Subject: Submittal Supporting Accelerated ABWR Schedule -  
**Radiation Protection Modifications to SSAR and CDM**

Enclosed are SSAR and CDM markups modifying selected pages of SSAR Chapter 12 and CDM Section 3.2.

## **SSAR MARKUPS**

## CDM MARKUPS

Figure 3.2g Reactor Building Radiation Zone Map for Full Power and Shutdown Operations, Floor B1F—Elevation 4800 mm

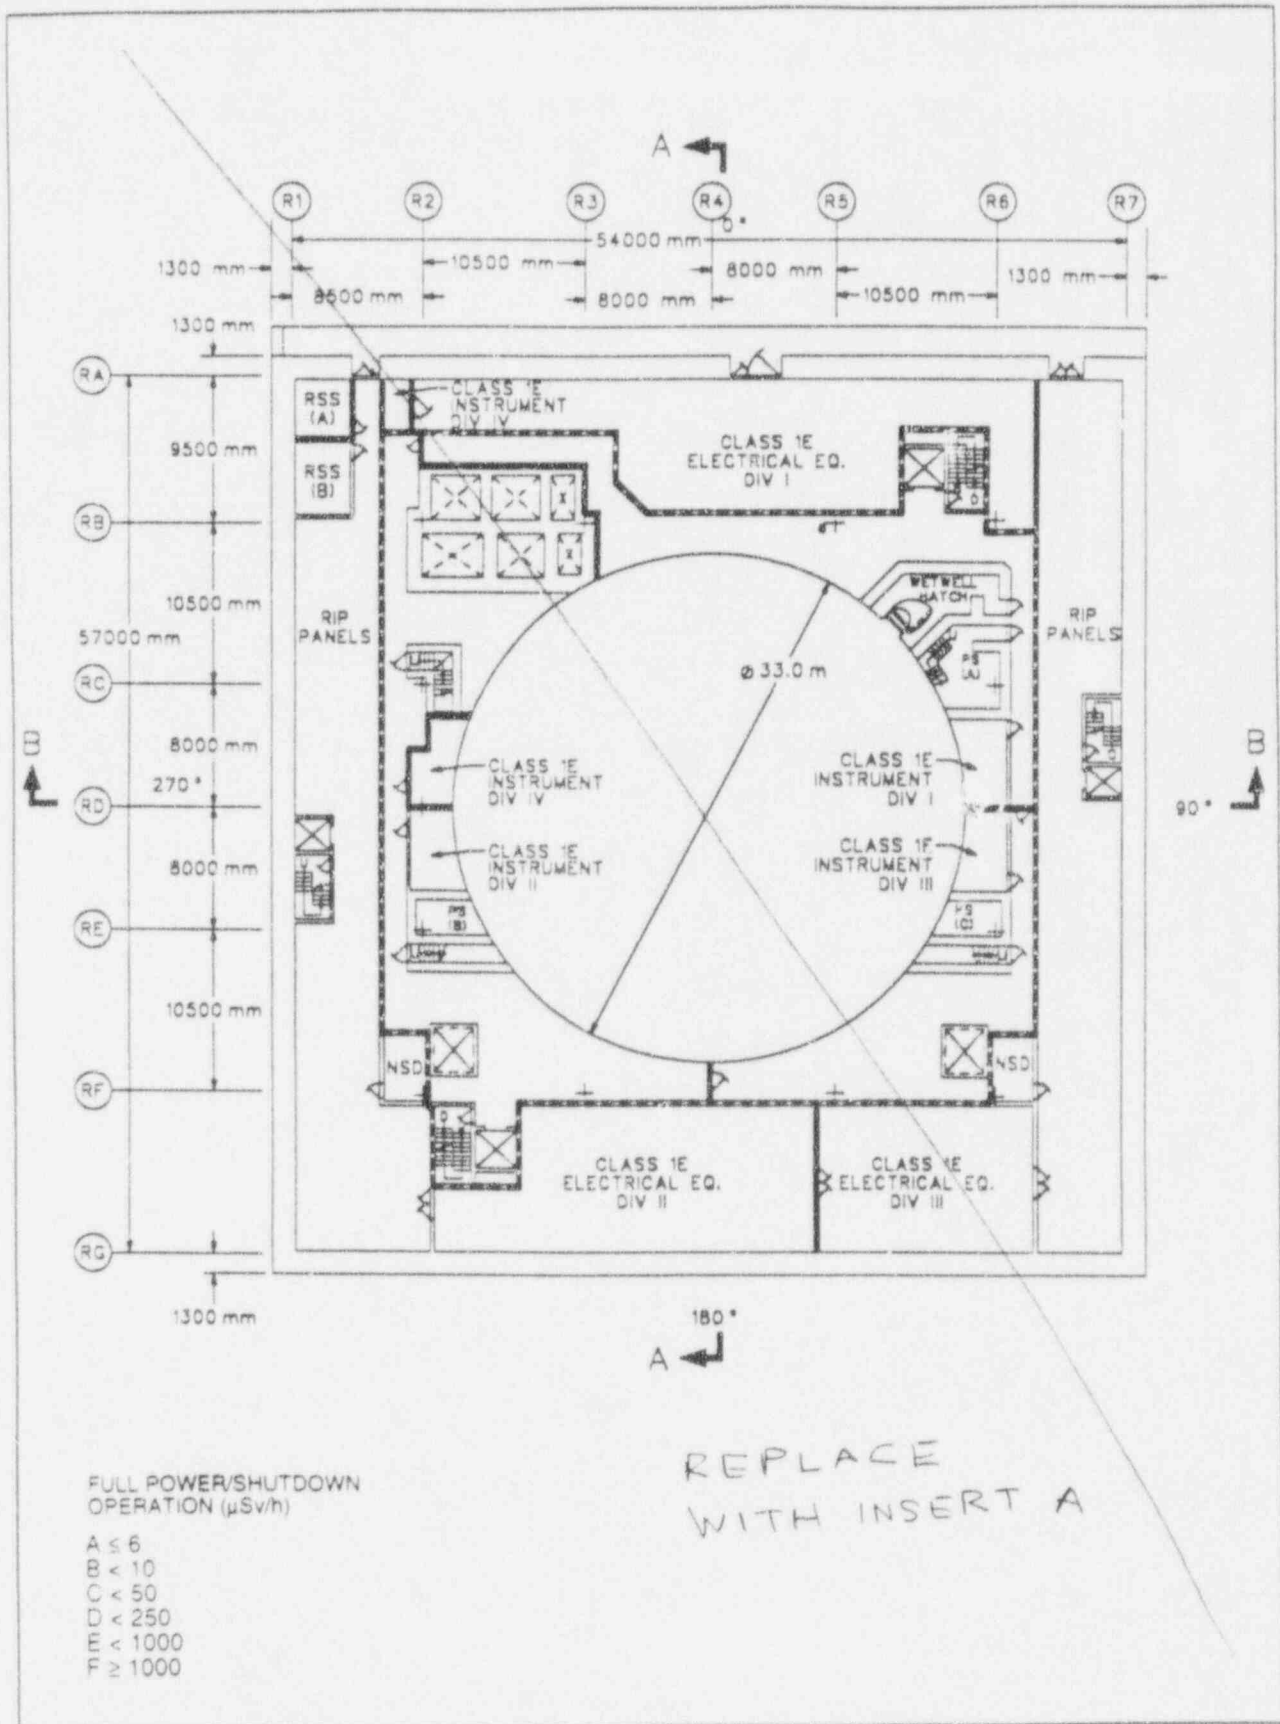
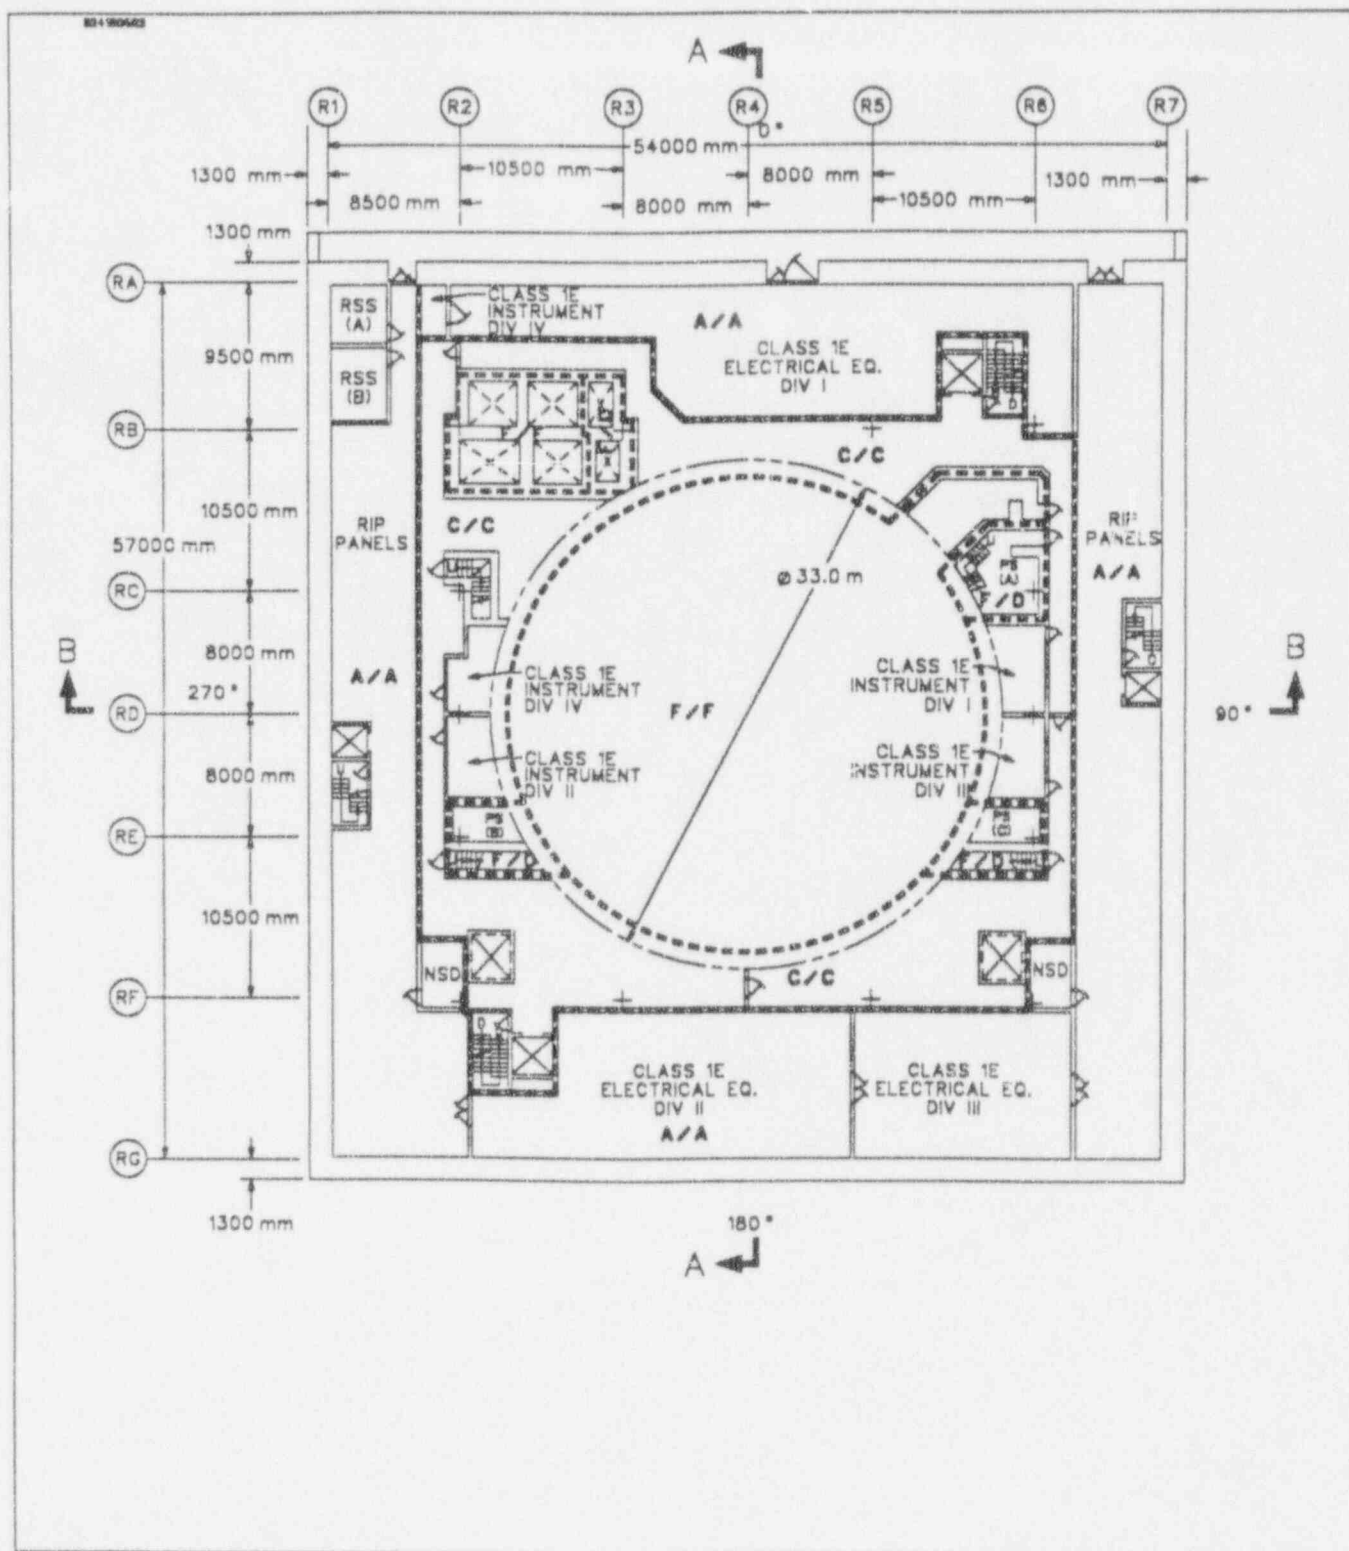
# INSERT A

Figure 3.2n Reactor Building Radiation Zone Map for Full Power and Shutdown Operations—Elevations 34500 mm and 38200 mm

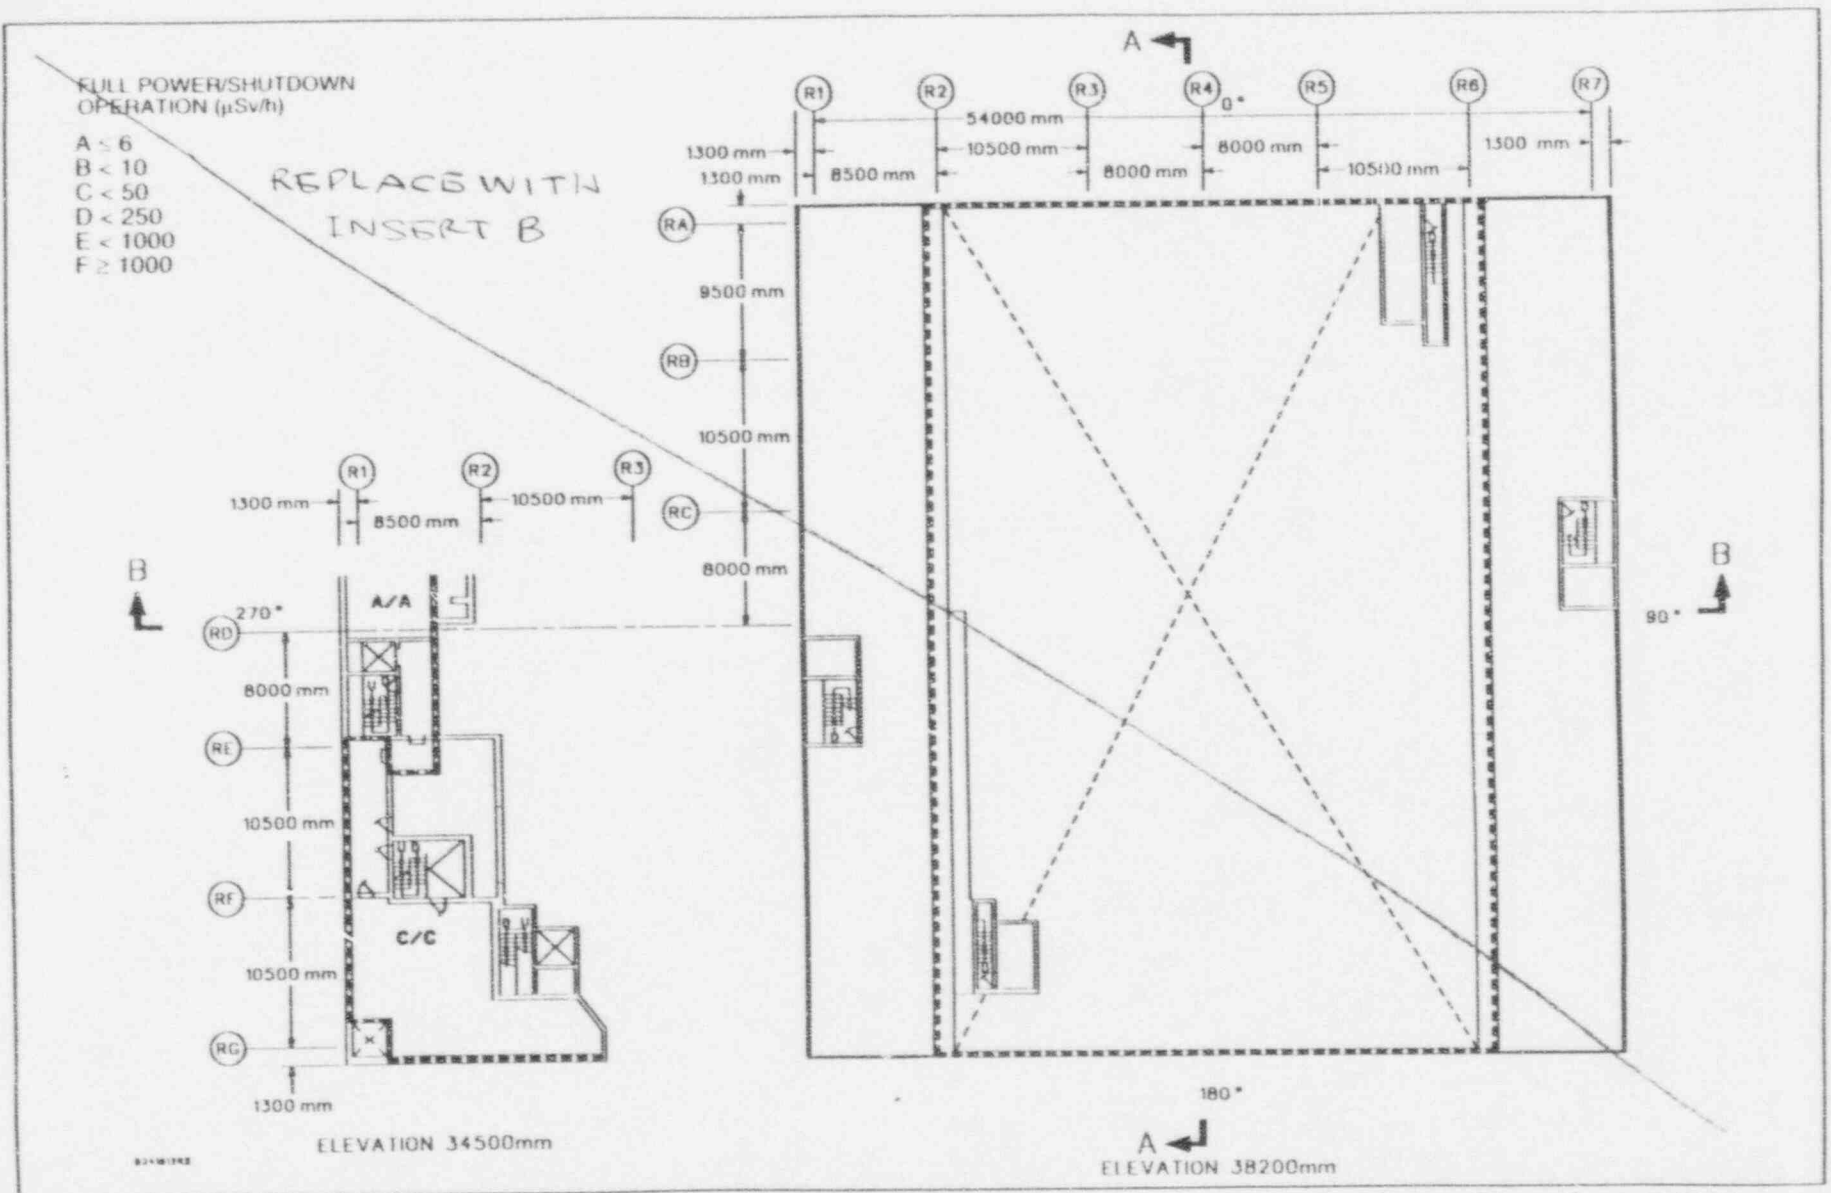
INSERT B
